102. EPoC PHY Link

Modify Figure 102-1 and 102-2 as shown below

Figure 102–8—Example, all subcarriers used for probing, no skipping

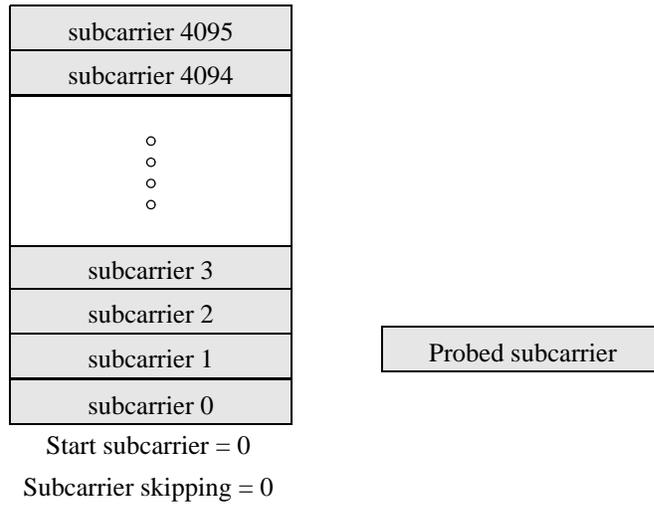
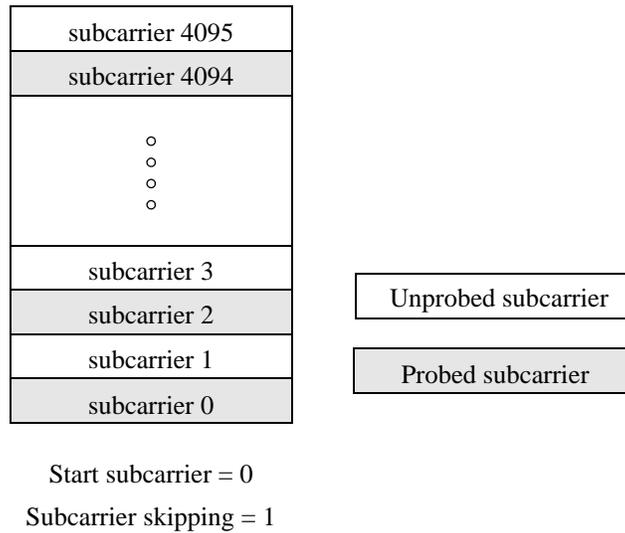
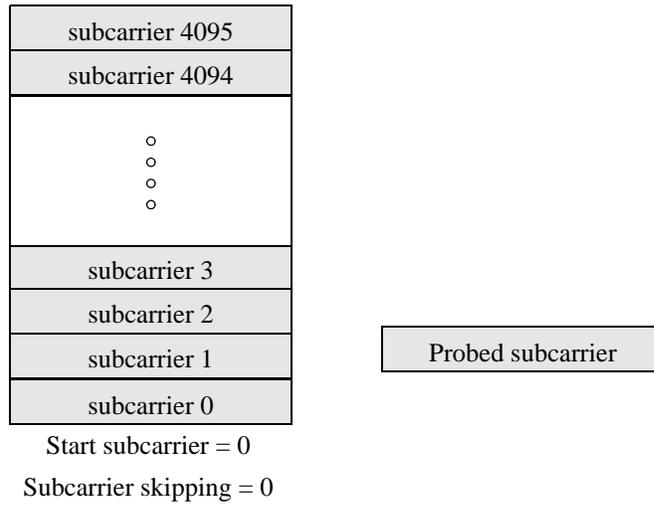
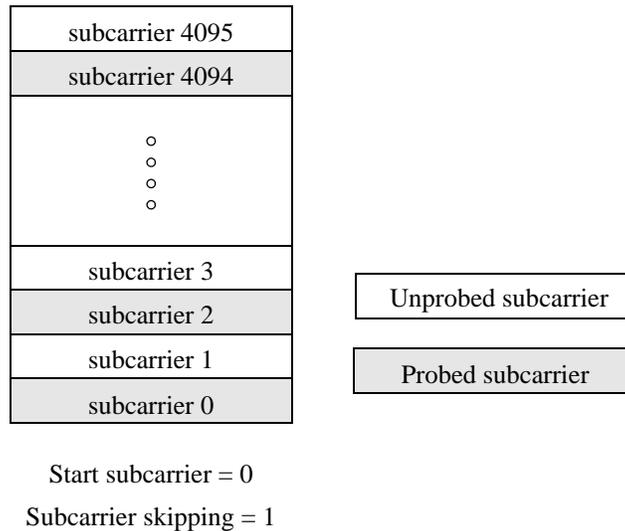
The CLT allocates subcarriers within a probing symbol by sending ~~two~~ five variables to the CNU: ~~ProbeStart~~ PrbStrtSC, ~~PrbSkp~~, ~~PrbEQ~~, StrtSym and ~~ProbeSkip~~. ~~The range of ProbeStart is from 0 to 7. The range of ProbeSkip is from 0 to 7~~ SymNum (see 102.4.3.6). Figure 102–8 and Figure 102–9 illustrate the use of ~~these variables~~ PrbStrtSC and PrbSkp. The CNU uses the start subcarrier and subcarrier skipping parameters to determine which subcarriers are to be used for probing transmission, as follows:

- The ~~ProbeStart~~ PrbStrtSC variable is the starting subcarrier number.
- The ~~ProbeSkip~~ PrbSkp variable is the number of subcarriers to be skipped between successive pilots. ~~ProbeSkip~~ PrbSkp = 0 implies no skipping of subcarriers (i.e., all subcarriers are used for probing).

Figure 102–11—Scheduling two CNU in the same probing symbol

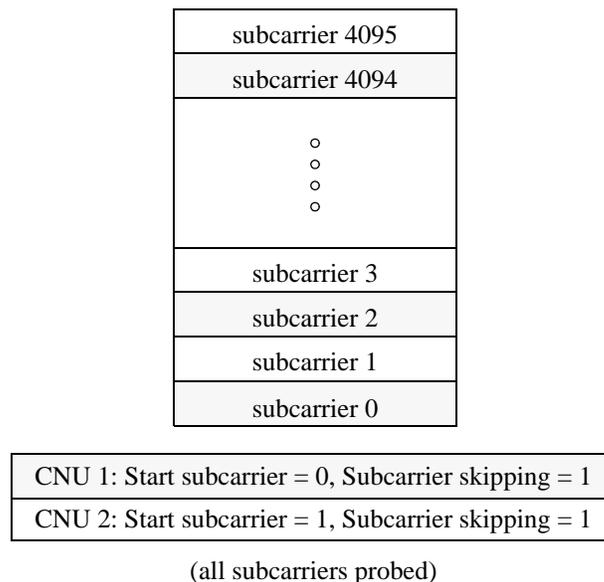
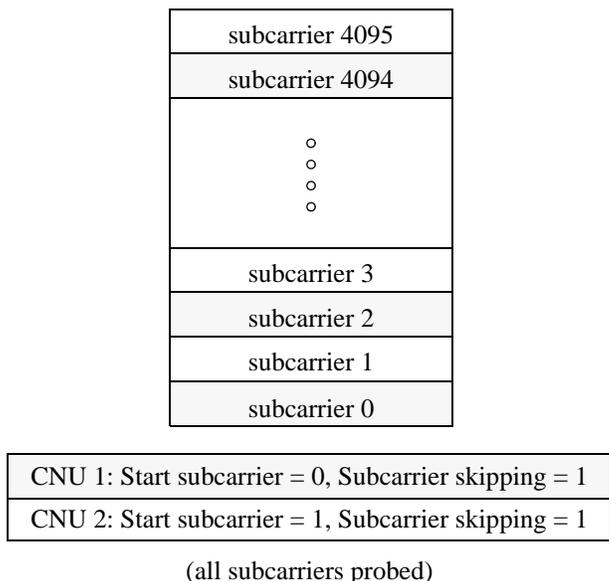
To schedule multiple CNUs in a probing symbol (as illustrated in Figure 102–11) the CLT does the following:

- 1) Allocate the same probing symbol at any given time to more than one CNU.
- 2) Assign a different ~~ProbeStart~~ PrbStrtSC number to each CNU.
- 3) Assign the same ~~ProbeSkip~~ PrbSkp value to every CNU within the probing symbol.

This method can be used with or without skipping subcarriers to create nulls. To create nulls, specify a ~~ProbeSkip~~ PrbSkp value equal to, or greater than, the number of CNUs in the pattern.

Figure 102-13—Probe sequence generator

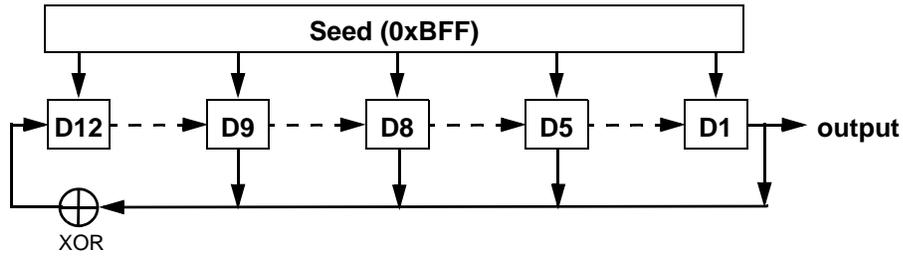
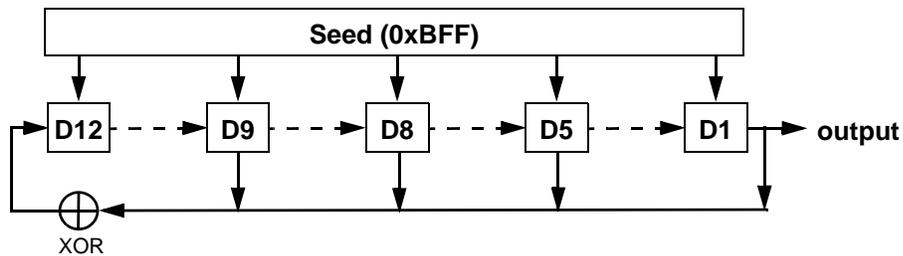
The Probe symbol shall be populated with a BPSK mapped bit sequence generated by a pseudo-random sequence generator defined by the polynomial $X^{12} + X^9 + X^8 + X^5 + 1$ seeded with a fixed bit pattern of 0xBFF at the beginning of each upstream superframe (illustrated in Figure 102–13). The output of the sequence generator is mapped using BPSK modulation (see 101.4.5.2) where a bit value of 0 is mapped to a BPSK value of plus1 and a bit value of 1 is mapped to a BPSK value of minus 1.

Figure 102–14—CNU Probe transmission control state diagram

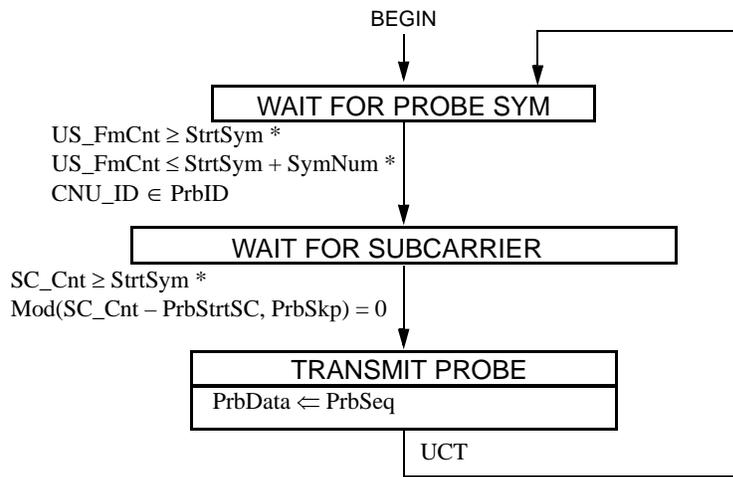
The CNU probe transmit process shall conform to the state diagram shown in Figure 102–14.

Figure 102–15—PrbID update state diagram

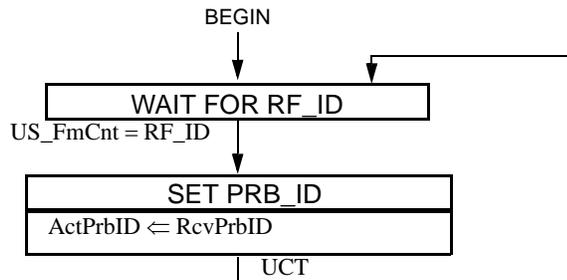
set of variables is updated with each downstream PHY Link frame when RF_ID = US_FmCnt (See Figure 102–15).	1
CNU_ID	2
See {ref}	3
PrbData	4
TYPE: bit array	5
This variable holds the probe sequence bits to be transmitted during the probe period.	6
ProbeDur	7
TYPE: boolean	8
This variable determines the number of Symbols in the Probe Period. When ProbeDur is FALSE there are five symbols in the Probe Period, when this variable is TRUE there are six symbols in the Probe Period.	9
PrbEQ	10
TYPE: Boolean	11
When this variable is TRUE the CNU transmits the probe symbol with equalization applied. When this variable is FALSE the CNU transmits the probe symbol without equalization applied.	12
Note the def for PrbEq is included here for clarity but should be placed in CI 101.4.4.5 Probe generator.	13
PrbSkp	14
TYPE: Integer	15
The value of this variable determines the number of subcarriers to be skipped in the probe symbol. The range of PrbSkp is from zero to seven.	16
